Yorkshire Green Energy Enablement (GREEN) Project

Document 8.3 Applicant's Response to Relevant Representations

Planning Inspectorate Reference: EN020024

Figure 22.3.1 – Requested alternative access route marked in yellow onto Works Plan Section B (Document 2.6.2) [APP-021].

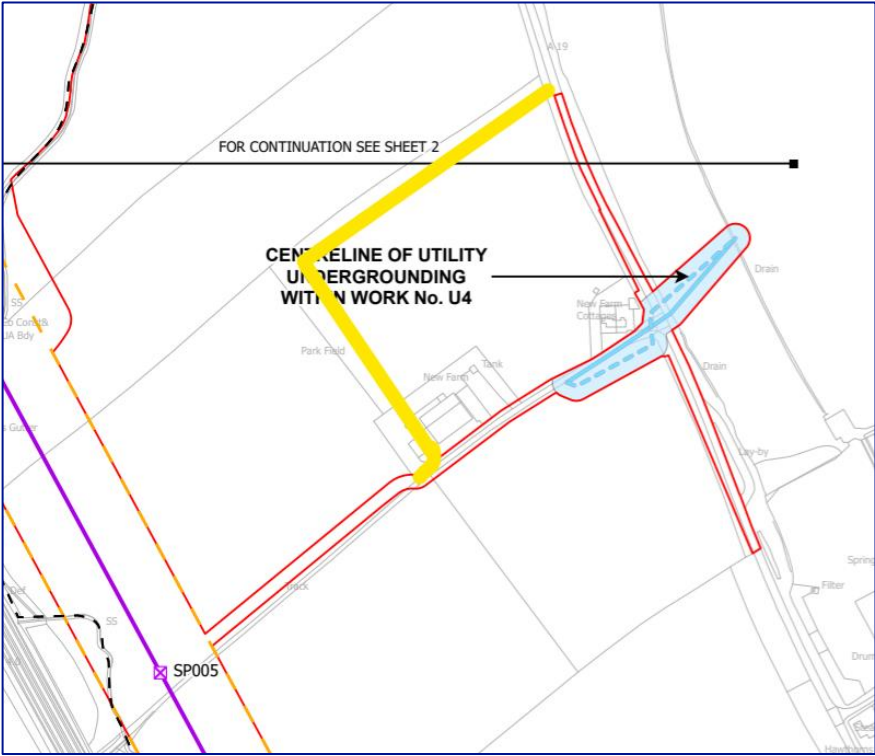
22.3	<p>The requirement to use the access at New Farm for the scheme will conflict with the agricultural use. Additionally, 2.6.2 shows there is undergrounding of utility work No U4 in the entrance. We request an alternative access track be provided through the existing gateway west from the A19 then south to the farmstead running next to the field boundaries. The existing gateway is next to the field boundary shown on Traffic Regulation Order plan 2.12.2 just south of TR13 and north of the red line denoting the extent of the works.</p>	<p>National Grid notes the request for a new alternative access to SP005 utilising the existing gateway in the field to the north of New Farm, south of TR13 within Traffic Regulation Order Plan Section B (Document 2.12.2) [APP-057].</p> <p>The access requested follows field boundaries to re-join back onto the current proposed access via the farmstead as interpreted in Figure 22.3.1, below (for illustrative purposes only).</p> <p>The length of the alternative access is approximately 490m, compared to the 230m of the current proposed access. The requested access, as interpreted, is shown below in Figure 22.3.1 in yellow (for illustrative purposes only). This has not</p>

The current proposal allows for a 40m wide bellmouth and a 12m access swathe from the A19 to pylon SP005. This is to allow the space required for crane access during pylon erection. Due to the size requirement of the access, it is necessary to dismantle and underground the 11kV overhead wires attached to the existing wood pole which is located in close proximity to the access entrance. This will need to be undertaken prior to overhead line construction works.

Figure 24.3.1 – Requested alternative access route marked in yellow onto Works Plan Section B (Document 2.6.2) [APP-021].

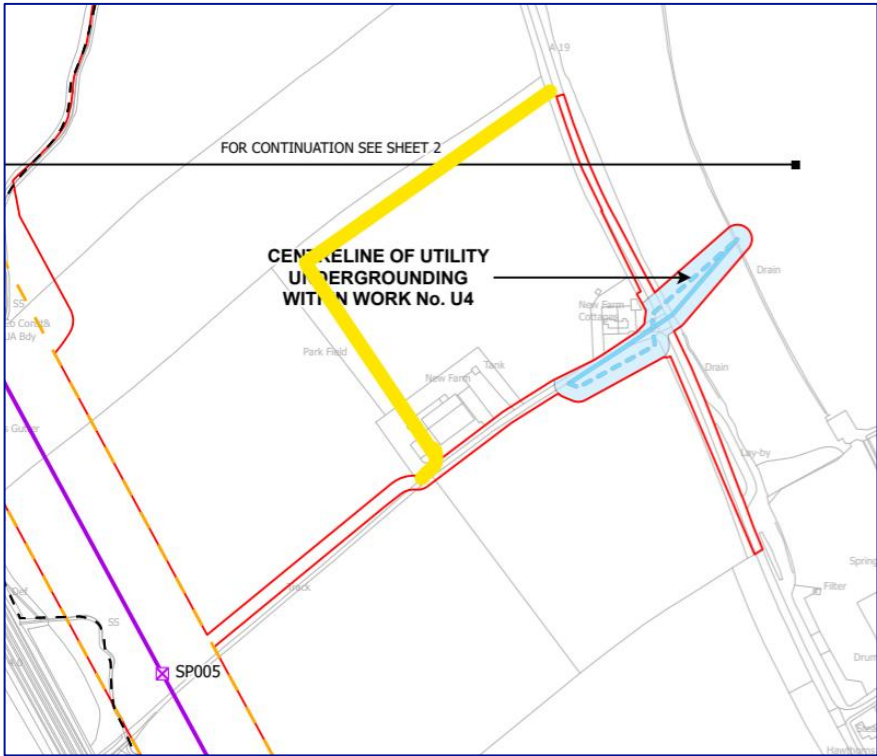
24.3	The requirement to use the access at New Farm for the scheme will conflict with the agricultural use. Additionally, 2.6.2 shows there is undergrounding of utility work No U4 in the entrance. We request an alternative access track be provided through the existing gateway west from the A19 then south to the farmstead running next to the field boundaries. The existing gateway is next to the field boundary shown on Traffic Regulation Order plan 2.12.2 just south of TR13 and north of the red line denoting the extent of the works.	<p>National Grid notes the request for a new alternative access to SP005 utilising the existing gateway in the field to the north of New Farm, south of TR13 within Traffic Regulation Order Plan Section B (Document 2.12.2) [APP-057].</p> <p>The access requested follows field boundaries to re-join back onto the current proposed access via the farmstead as interpreted in Figure 24.3.1, below (for illustrative purposes only).</p> <p>The length of the alternative access is approximately 490m, compared to the 230m of the current proposed access. The requested access, as interpreted, is shown below in Figure 24.3.1 in yellow (for illustrative purposes only). This has not been assessed as part of the application for the Project and is outside of the Order limits.</p>

The current proposal allows for a 40m wide bellmouth and a 12m access swathe from the A19 to pylon SP005. This is to allow the space required for crane access during pylon erection. Due to the size requirement of the access, it is necessary to dismantle and underground the 11kV overhead wires attached to the existing wood pole which is located in close proximity to the access entrance. This will need to be undertaken prior to overhead line construction works.
